Access Compliance Report

Public Rights-of-Way

Intersection ID: 29367	Main Street: MOSSY_OAK_LN	Cross Street: SUMMIT_HILLS_DR	Location: NE
ADA ID: 4B3D6E0D2C70	Ramp Type: PerpDiag	Initial Pass/Fail: Fail	Overall Compliance: No
		Severity Score: 8.75

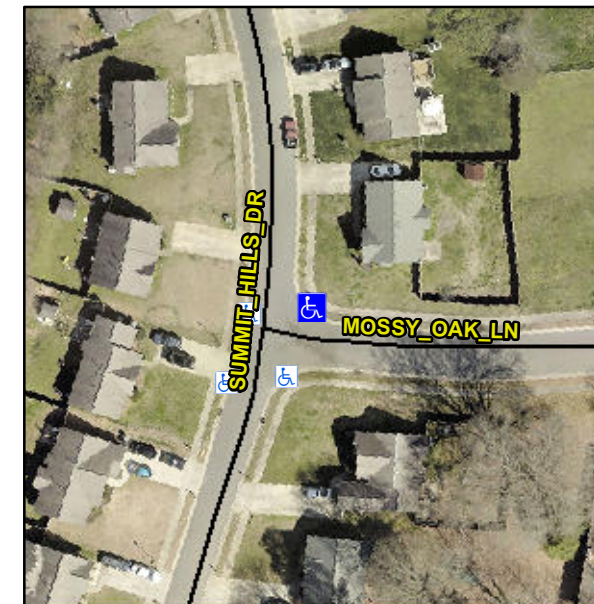
R304.5.1

Compliance	Description	Data	Compliance	Description	Data
N/A	Ramp Length (in)	50.0	Yes	Ramp Slope (%)	5.0
No	Ramp Width (in)	45.0	Yes	Ramp XSlope (%)	0.9
N/A	Flare Type LT	N/A	N/A	Flare Type RT	N/A
N/A	Flare Slope LT (%)	N/A	N/A	Flare Slope RT (%)	N/A
N/A	Flare Traversable LT?	N/A	N/A	Flare Traversable RT?	N/A
N/A	Landing Length (in)	N/A	N/A	DWS Provided?	N/A
N/A	Landing Width (in)	N/A	N/A	DWS Contrast?	N/A
N/A	Landing Slope (%)	N/A	N/A	DWS Length (in)	N/A
N/A	Landing X Slope (%)	N/A	N/A	DWS Full Width?	N/A
N/A	Landing Curb? (Y/N)	N/A	N/A	DWS Offset (in)	N/A
N/A	Shared Landing?	N/A			
N/A	Gutter Ponding?	N/A	N/A	Gutter Slope (%)	N/A
N/A	Gutter Lip Ht (in)	N/A	N/A	Gutter X Slope (%)	N/A
N/A	Painted X Walk1?	No	N/A	Painted X Walk2?	No
	X Walk 1 Direction	To W		X Walk 2 Direction	To S
N/A	X Walk 1 Width (in)	N/A	N/A	X Walk 2 Width (in)	N/A
	X Walk 1 Slope (%)	3.3		X Walk 2 Slope (%)	0.9
	X Walk 1 X Slope (%)	0.9		X Walk 2 X Slope (%)	0.7

Remove & Replace Curb Ramp With Two New Directional Ramps or Equivalent.
